Section 42A Officer's Report

Stream #3: Residential and Rural

Subjects: Residential Zones

Rezoning

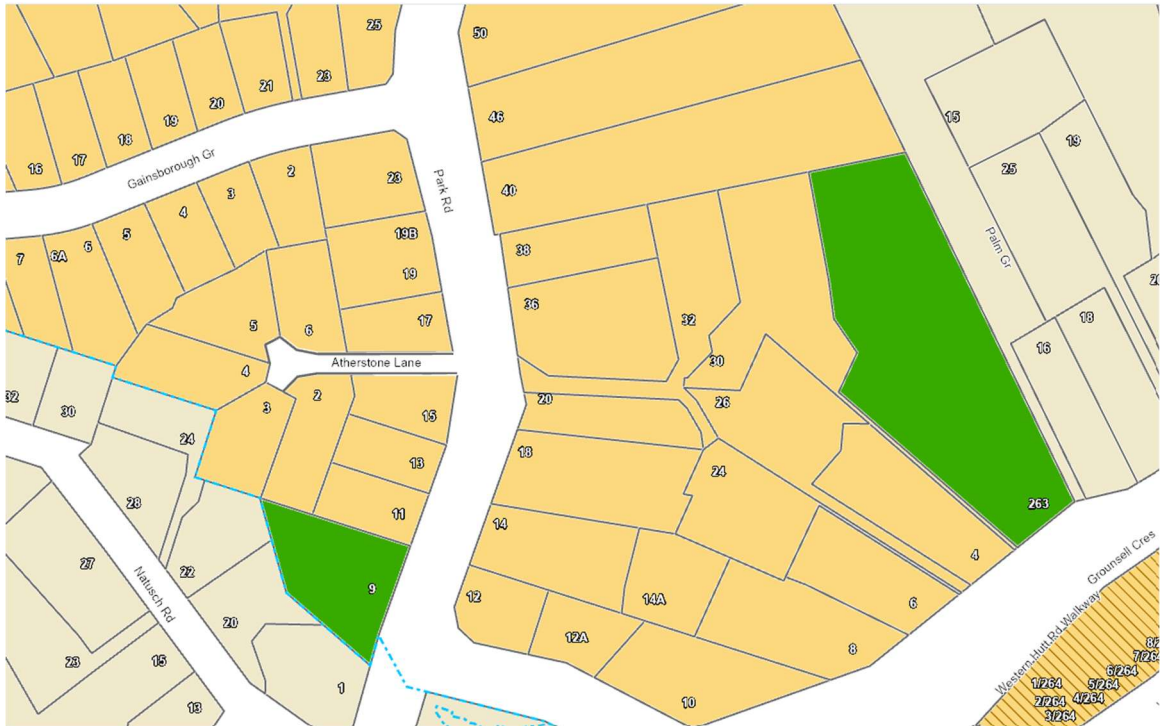
- (461) Argosy Property No.1 Limited [237.58] opposes the MRZ between Randwick Road, Waione Street and Commercial/Industrial/Open Space zones,

including Tirangi Road, Pitt Street, Pirie Crescent, Croft Grove, Okoutu Lane (see original submission for map). This submitter seeks that the planning maps are amended to place the area of MRZ on the west side of Randwick Road within the HRZ (see original submission for map). Reasons include consistency with 39 and 51 Randwick Road.

Figure 2 Revised Indicative Zoning Layout sought for 452 Cambridge Terrace (supplied by submitter)

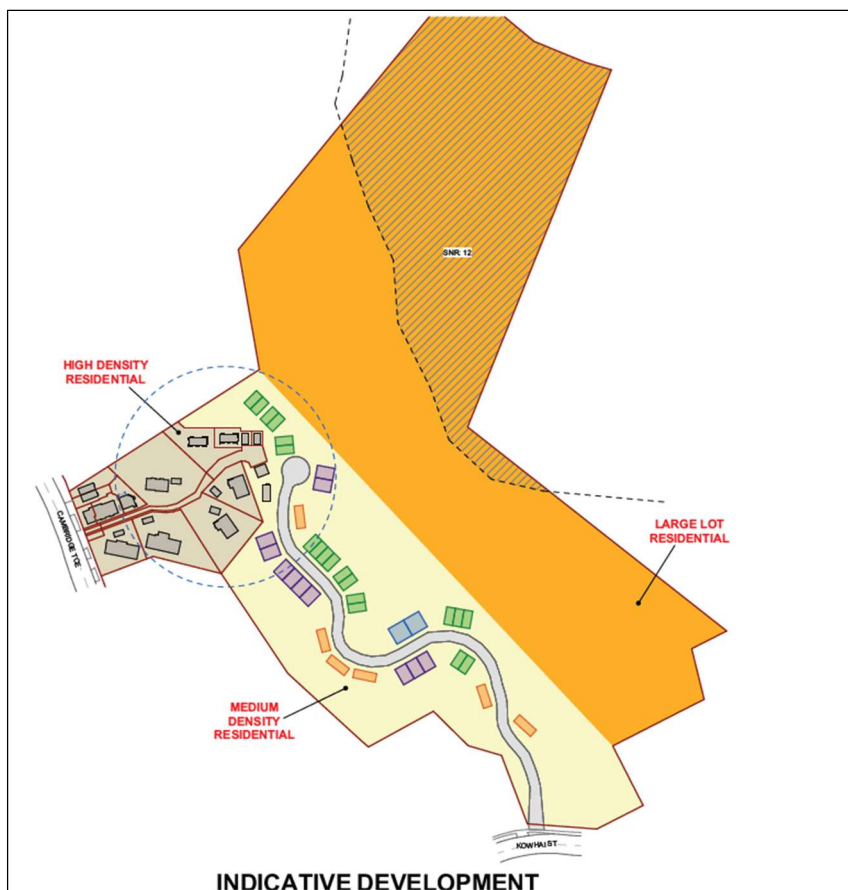
- (512) Lucas Land Surveys Limited seek the rezoning of 443 Cambridge Terrace and 452 Cambridge Terrace to Medium Density Residential from Large Lot Residential Zone. Design Network Architecture and John Havler seek the rezoning of the adjoining site at 452 Cambridge Terrace to Medium Density Residential. I note the ODP and PDP maps show 443 Cambridge Terrace is already zoned High Density Residential. In terms of 452 Cambridge Terrace, the site is zoned Hill Residential Activity Area under the ODP.

- (513) The relief sought in the original submissions is for the entire site at 452 Cambridge Terrace to be rezoned. The site has an area of approximately 7.3 hectares and is an elevated site. I understand from discussions with the submitters that they have revised their plans for the development of the site for medium density development, following assessment of the site constraints such as slope and vegetation cover. It is noted that part of the site is within SNR: 12 Eastern Hills Bush. The submitter has therefore revised their relief sought to retain that portion of the site within SNR:12 (plus some additional land outside that overlay) as LLRZ, and to rezone the lower part of the site, outside of the SNR overlay, to MRZ. This indicative zoning layout is shown in below in **Error! Reference source not found..**

- (514) I also note the majority of the site is subject to the Slope Assessment Overlay, which will trigger a geotechnical assessment for any future development of the site.

Figure 3 LLRZ properties on Holborn Drive

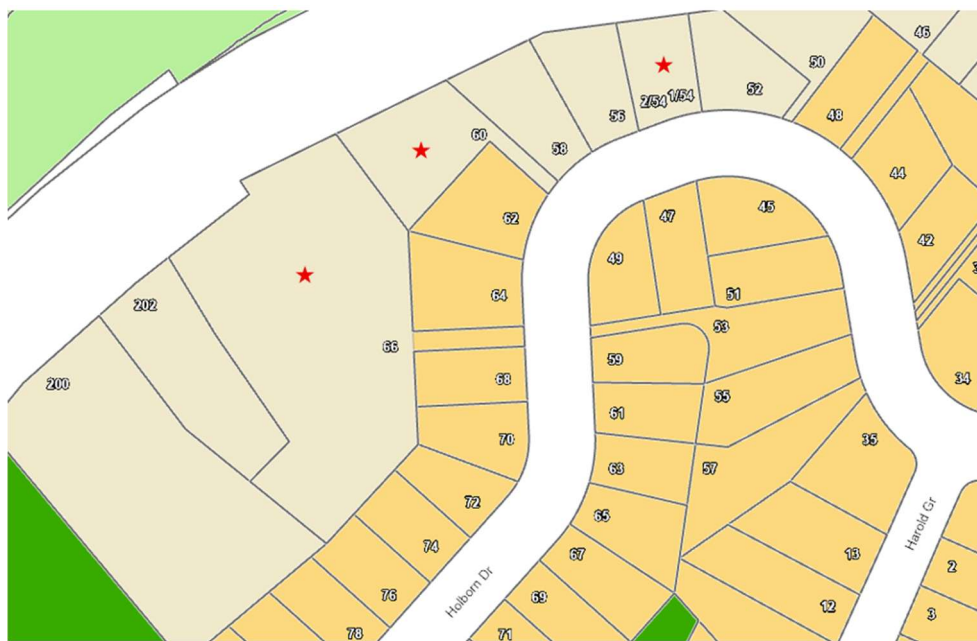
(523) Tim Phillips [64.1], Carleen Richards [117.1] and Rachel and James Prier [300.1], seek the rezoning of their properties on Holborn Drive (being 60, 1/54, and 66 respectively) from LLRZ to MRZ. I have reviewed these requests in terms of the criteria the Council has applied to identify locations for the LLRZ and the MRZ. While these properties generally meet the MRZ criteria, particularly in terms of access and three waters connections, I note these properties are within a section of Holborn Drive that is zoned LLRZ i.e.

adjoining properties are LLRZ, as shown in Figure 3 . No submissions have been received to rezone the block in its entirety, such that rezoning individual sites to MRZ would result in an inconsistent zoning pattern which may create unintended consequences for the adjoining properties that remain as LLRZ.

- (524) In my opinion, a consolidated zoning pattern that supports general consistency in built form is preferable to an ad hoc approach of enabling greater density on individual sites within a predominantly low-density environment. On this basis, I recommend rejecting the relief sought and retaining the LLRZ at 1/54, 60, and 66 Holborn Drive.

Figure 5 Properties on lower Korokoro slopes recommended to retain MRZ

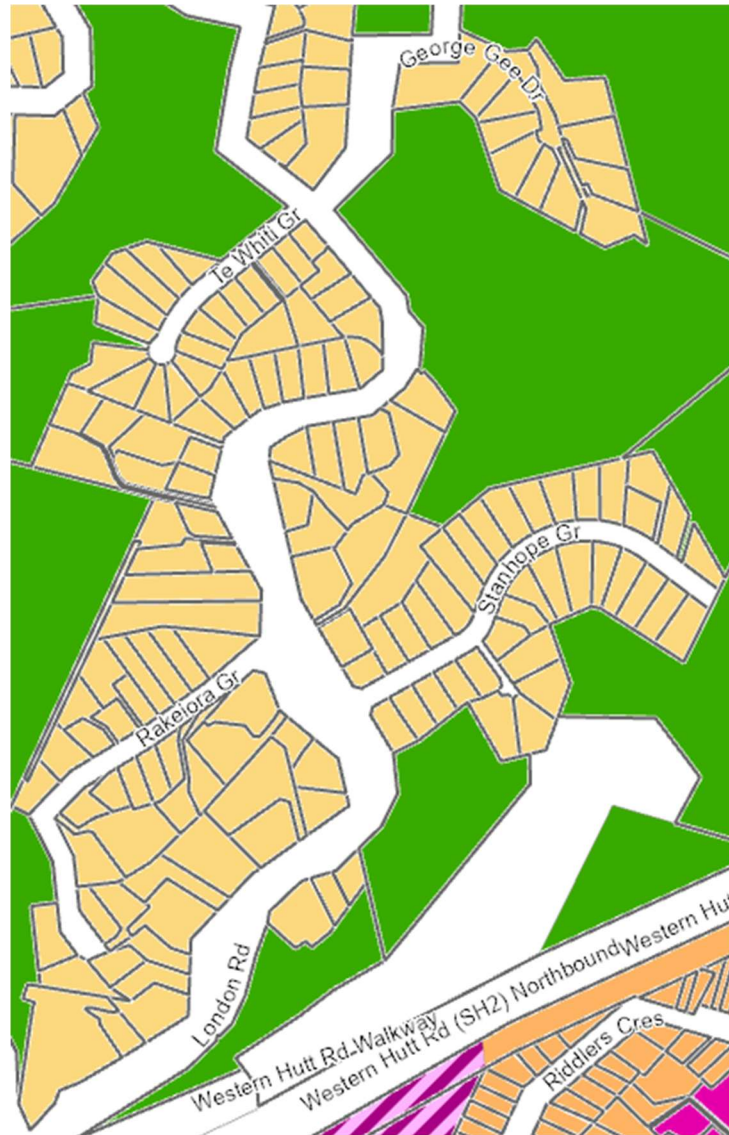
- the MRZ should be retained for properties on London Road, from the intersection with Korokoro Road to George Dee Drive, including Rakeiora Gr, Stanhope Gr, Te Whiti Gr & George Gee Dr shown in Figure 5 below.

(554) Accordingly, I recommend accepting in part the relief sought by Michael Stewart [481.1], and rejecting the relief sought by Rebecca Leask et al [472.1, 472.2 and 472.3] and Lorraine Mansfield [216.1 and 216.2].

Figure 7 Area on Randwick Road proposed for rezoning from MRZ to HRZ by Argosy Property No.1

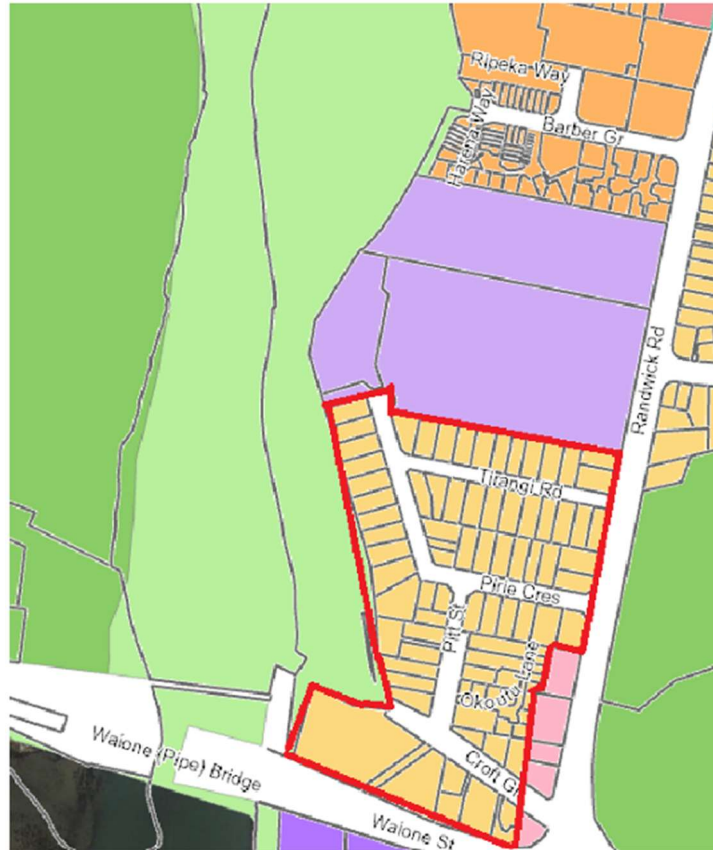
Argosy Property No.1 seeks that the area shown in

- (555) Figure 7 is rezoned from MRZ to HRZ, due to inconsistency with the zoning of 39 and 51 Randwick Road:

- (556) This area is located outside of the walkable catchments for HRZ that the Council applied through PC56 in accordance with Policy 3 of the NPS-UD. As such, the MRZ was applied to these properties.
